**Victorian Planning Authority Projects Standing Advisory Committee – Referral 2
Report**

**Draft Monash Planning Scheme Amendment C156mona
PMP Printing Precinct Comprehensive Development Plan**

14 April 2021

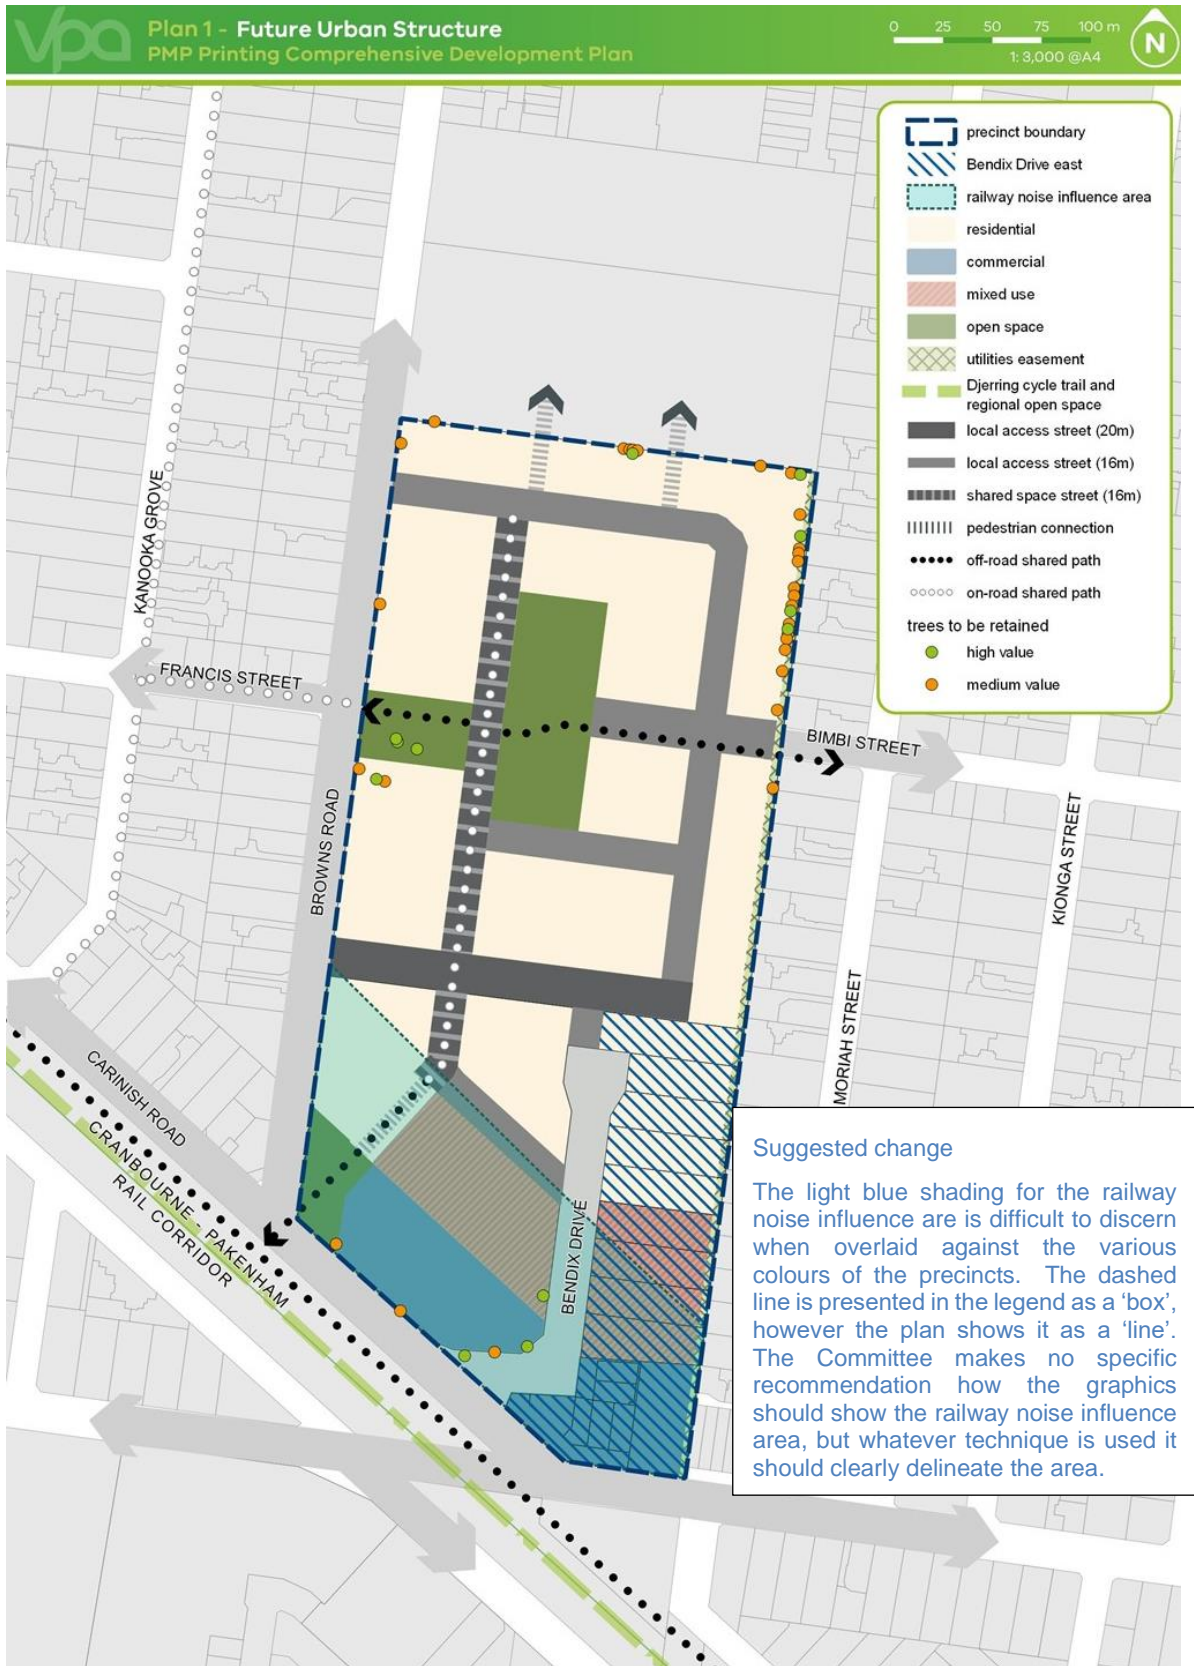
The Committee considers the graphical representation of the railway noise influence area needs to be better resolved on the Future Urban Structure (and all the associated plans where it is reproduced). The light blue shading is difficult to discern when overlaid against the various colours of the precincts. The dashed line is presented in the legend as a ‘box’, however the plan shows it as a ‘line’. The Committee makes no specific recommendation how the graphics should show the railway noise influence area, but whatever technique is used it should clearly delineate the area.

Although the Committee does not have any issue with the term ‘railway noise influence area’, it notes that there is now no reference to a distance of 135 metres from the railway tracks. It may assist future users of the plan if the distance of 135 metres measured from the centre of the nearest track associated with the railway line was shown on the plan. This may assist applicants and decision makers to understand the precise location of the limit of the railway noise influence area within the subject land.

The Committee notes that the Future Urban Structure plan is used as the ‘base plan’ for the other plans in the CDP. Any changes to the Future Urban Structure plan should be reflected in the other plans in the CDP, as appropriate.

The Future Urban Structure plan in Schedule 2 to the CDZ should also be updated to reflect the changes in the CDP to ensure there is consistency between the CDP and the CDZ.
